Block 21 Section 30 Dickson, ACT – Referral Entity Submissions for new DA No 201835109

Response Date 5 April 2019

Block 21 Section 30 Dickson, ACT – Submission by City Renewal Authority for new DA No 201835109  
 Response Date 30 May 2019

Project Name and Location						
DICKSON MIXED USE PROJECT						
BLOCK 21 SECTION 30 DICKSON ACT						
Drawing Title						
WASTE MANAGEMENT PLAN						
Project Number	Type	Discipline	Sub-Discipline	Drg No.	Rev	
181174	DRG	CIV	WM	1101	E

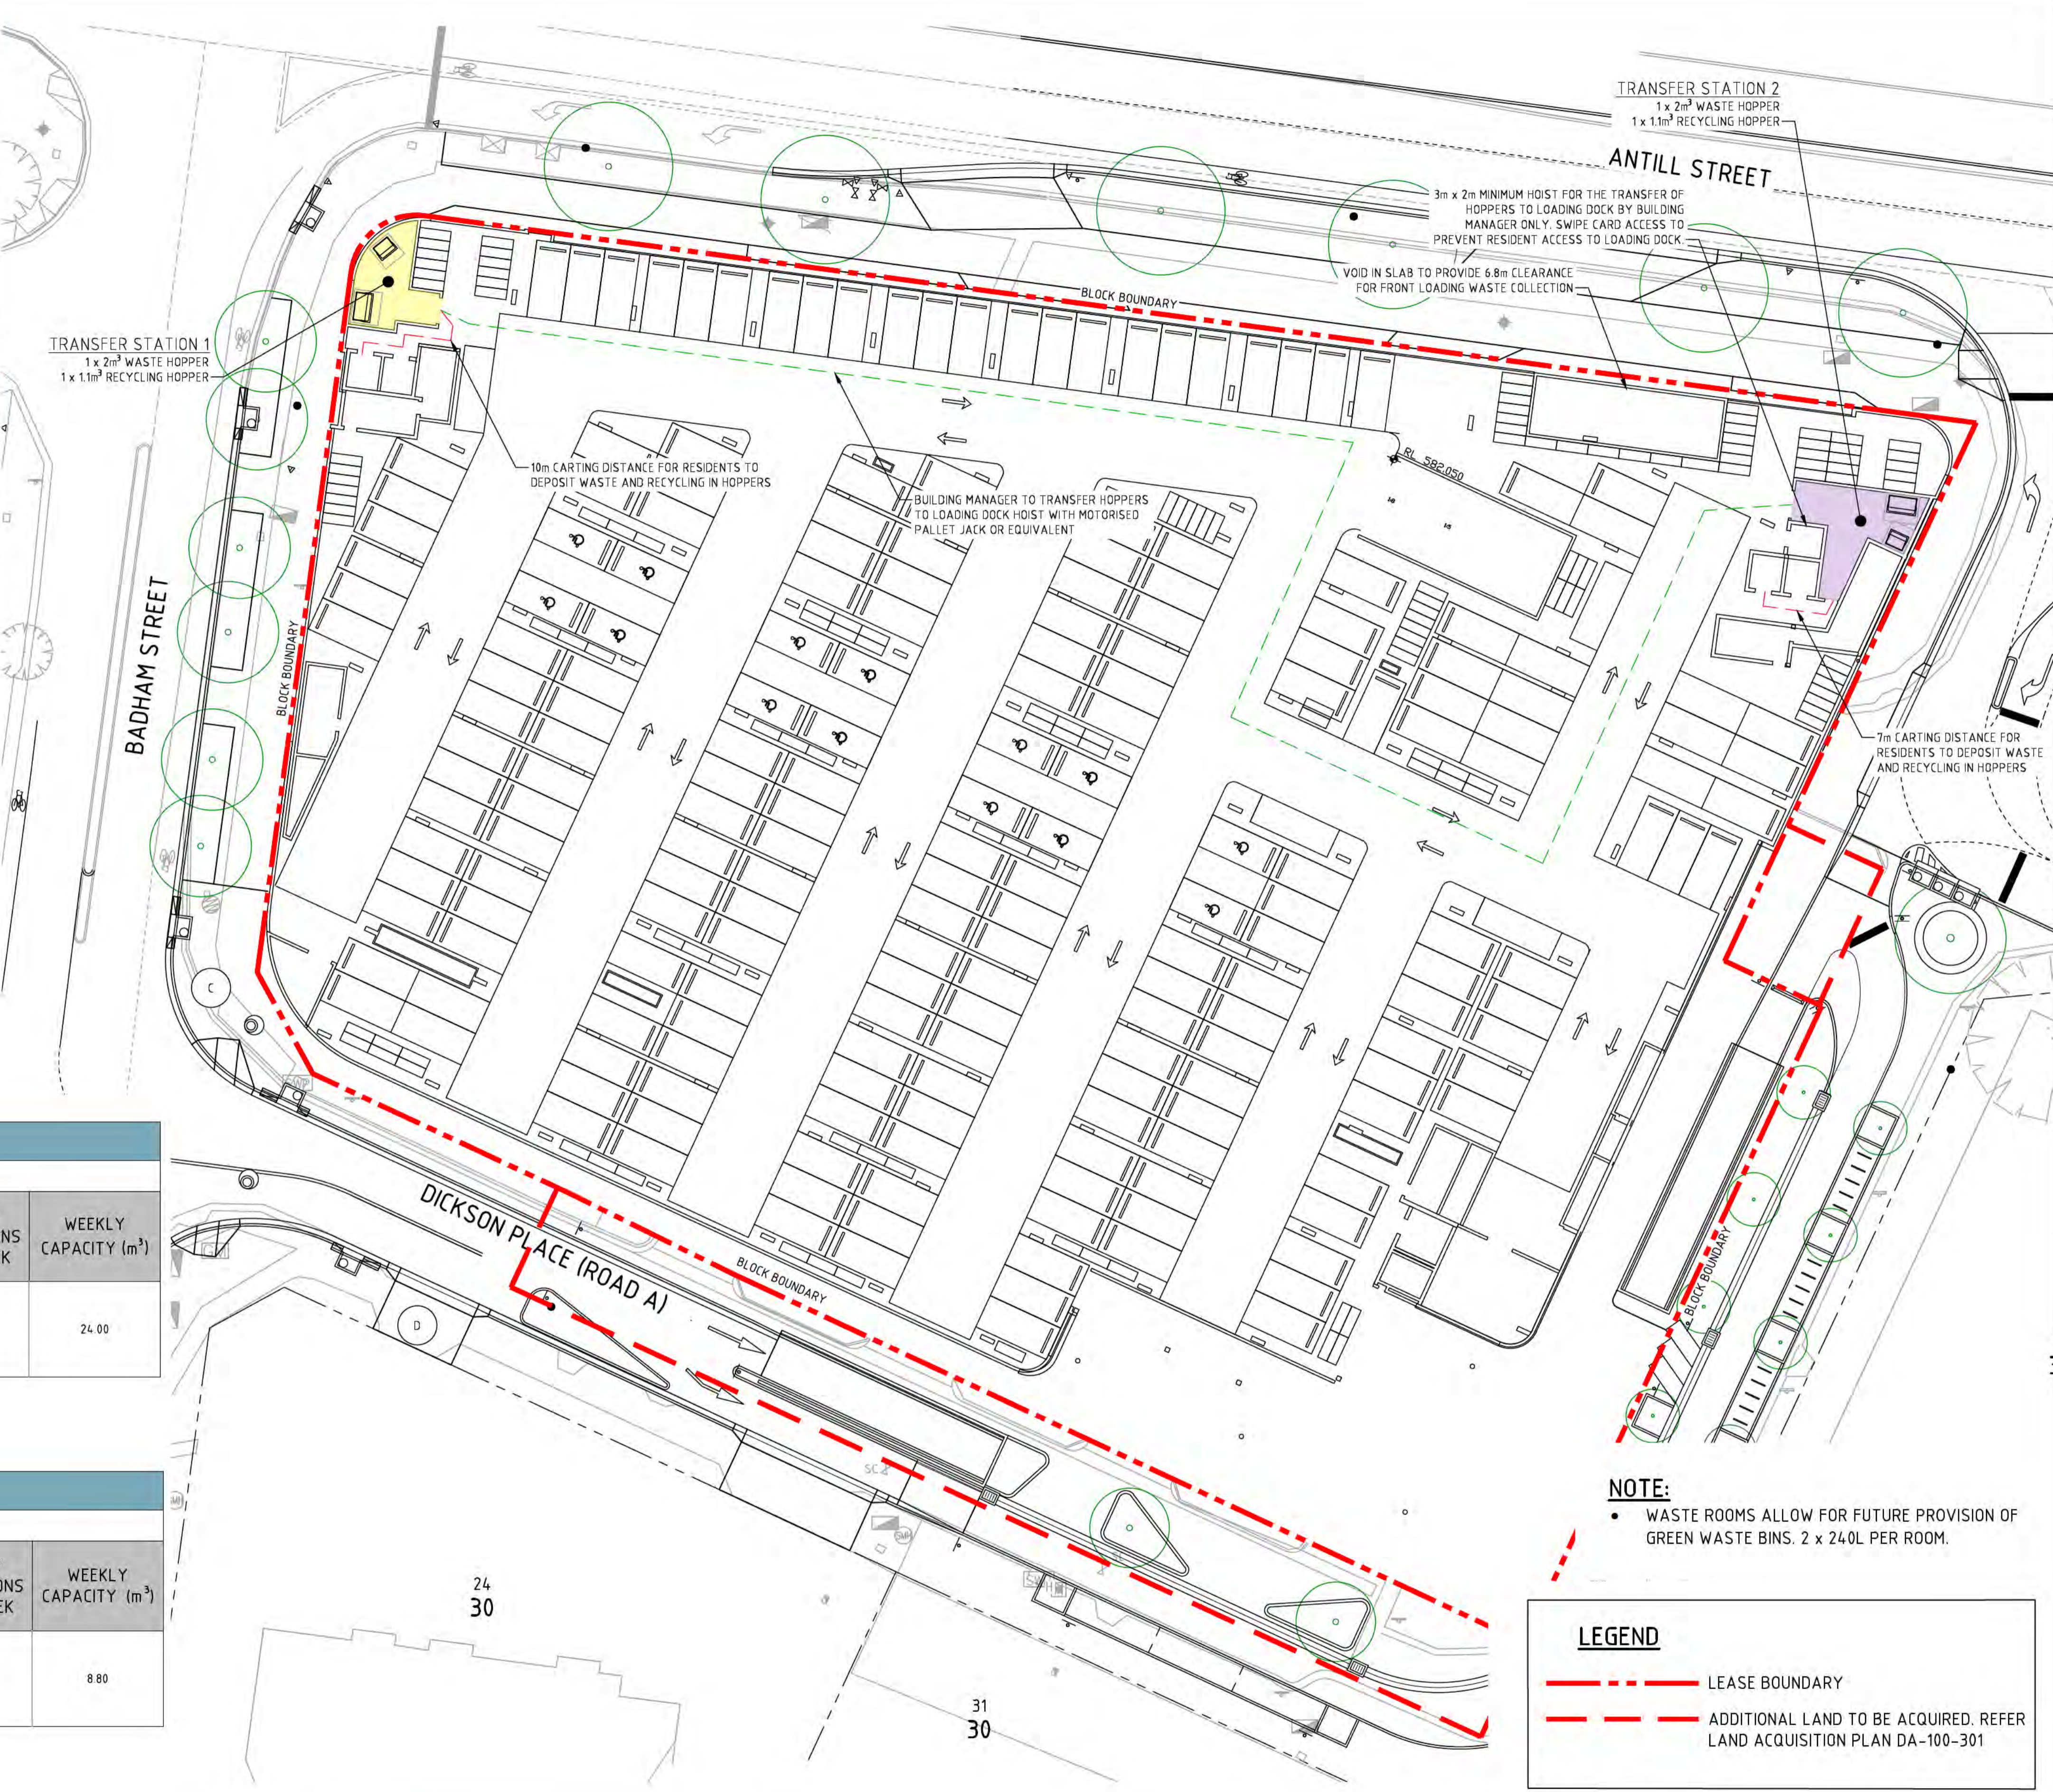
6.5	Transport Canberra and City Services	<u>Comments</u> WASTE 4. The submission must include supporting documentation that is either fully compliant with the 2016 Waste Code or the Development Control Code for Best Practice Waste Management in the Act 2019 (Code can't be mixed 'n' matched).	Please see attached <b>amended</b> Waste Management Plan showing that the development is fully compliant with the 2016 Waste Code.

Drawing Reference numbers		
Development Satisfies Control C7 (Section 2.5) of The Code		YES <input type="checkbox"/> ▼
Development Satisfies Appendix 7 of The Code		YES <input type="checkbox"/> ▼
Please provide details if Code requirements are not satisfied and proposed alternatives		
<b>How will waste and recycling be transferred from each dwelling to external storage area?</b>		
Description		
Waste will be transferred to the collection room located at the lift cores by residents. Hoppers in the collection areas on the first floor will be transferred to the waste enclosure on the ground floor by building management using an automated pallet jack and hoist.

Drawing Reference numbers	181174-drg-civ-wm-1101, 181174-drg-civ-wm-1102
